MAYOR AND COUNCIL COMMUNICATION

Landucci Property Sketch Plan Review

Sketch Plan Review – Landucci Property

RE: Landucci Property - Sketch Plan Review and Comp Plan Amendment Request

CONCEPT PLAN

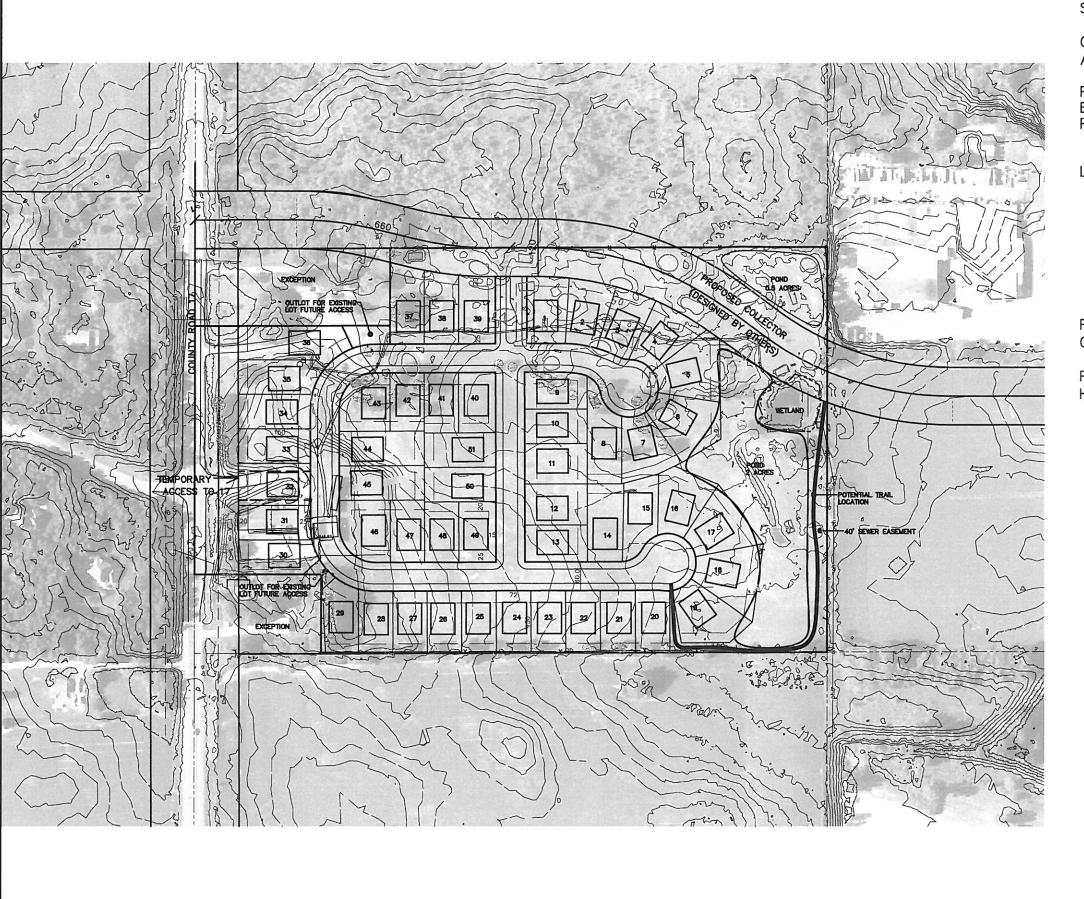
- Concept Plan. The concept plan includes a proposed configuration of roads, lots, wetlands, ponding areas, trails and open space areas on the applicant's site and additional details concerning the site data. The lots being proposed are generally consistent with the City's LDR (Low Density Residential) district standards. The applicant has also been coordinating with the northern property owner on an alignment of the 5th Street collector road that will bring this road across the boundary between these parcels. The collector road as shown will need to comply with the City's Engineering and Design standards.

- Land Use. The proposed Sketch Plan does not conform to the City's future land use plan; the applicant has therefore submitted a request for a Comprehensive Plan Amendment in conjunction with the sketch plan. If the City does not approve this amendment, the sketch plan cannot move forward.
- *Density*. The proposed Sketch Plan includes calculations for the gross (all of the land) densities over the planning area. The applicant should provide a net density calculation

- o The project is not located in an area that will be subject to required buffering.
- Staff is recommending that the applicant provide additional screening an/or buffering from the property to the south, which is planned for commercial development.

- O The sketch plan does not depict any areas that would be set aside to meet the park dedication requirements. There is a trail connection shown along the eastern border of the subdivision that will provide a trail access from the 5th Street Collector road into the subdivision.

O The proposed intersection of the 5th Street minor collector road and Lake Elmo Avenue is consistent with the City's initial transportation planning efforts in this area. It does not appear that it will be possible to provide two access points into

- the proposed development from 5th Street due to the City's access spacing guidelines for collector roads.
- The 5th Street collector road must be platted and constructed as part of the applicant's subdivision request.

- Staff is encouraging the applicant to provide a secondary emergency access to the site either via a gated or controlled access to Lake Elmo Avenue or over the proposed trail connection along the eastern side of the subdivision. The City will also need access to the storm water ponding areas.

- All residential streets shall be constructed to a 28-foot width from back of curb to back of curb per the city standard details. Right-of-ways must be a minimum 60 feet.

- o Ten (10) foot utility easements are required on both sides of the right-of-way.
- O Six (6) foot sidewalks must be provided along all continuous residential streets and along other streets as may be required for connectivity.

- O All street intersections must be at 90 degrees and maintain 100 feet of tangent with maximum slopes of 2% for first 100 feet.
- o Residential maximum longitudinal grade is 8% with no sidewalks, 6% where there are sidewalks.

- o Minimum diameter cul-de-sac is 90 feet with 120-foot right-of-way.
- The applicant should consider shared mailboxes in order to alleviate any potential snow plowing and storage problems within the cul-de-dacs.

- O Public water service is not yet available to the site. The applicant has submitted a letter requesting that the City extend public water service to the site in 2014. The City Council considered a feasibility study for such a project at its September 17th meeting. Should the City not proceed with extending water to the site, the applicant will need to address this issue before proceeding with a preliminary plat.
- Hydrant and valve placement will be made per City standards and as laid out by City staff.
- O Sanitary sewer service will be made available to the site via the Village trunk line construction project. The City is currently working with the applicant to align the proposed sewer line with the 5th Street collector road.

- O The proposed development area resides within the Valley Branch Watershed District (VBWD). City staff recommends early planning/coordination meetings with VBWD.
- O The design of the storm water management systems must be compliant with the requirements of the VBWD, the City of Lake Elmo Storm Water Management Ordinance, and the City of Lake Elmo design standards manual.

- o The applicant is advised to fully read and comprehend the City's storm water and erosion control ordinance since these standards are different, and in some cases more stringent, than the watershed district.
- o It is the applicant's responsibility to creatively plan for adequate storm water ponding and infiltration facilities.
- The storm water facilities should be platted as Outlots and deeded to the City for maintenance purposes. The storm water ponds will not be allowed to encroach on to adjacent private lots.
- Storm water facilities should have sufficient contributing drainage sheds (following guidelines of the MN Storm Water Manual) to facilitate proper operation.

- o Based upon the existing conditions of the site, the residential subdivision will require substantial grading activity. All grading activities shall meet the approval of the City Engineer.
- Subdivision Review Process. In order to proceed with the subdivision of the land included in the Sketch Plan area the applicant will need to next prepare a Preliminary Plat application. At this stage there is much more information required as part of the submission process, which also requires a public hearing. Ryland Homes has not yet indicated when they intend to submit a Preliminary Plat application.
- *Environmental Review*. The proposed development under the Sketch Plan does not trigger a mandatory environmental review.
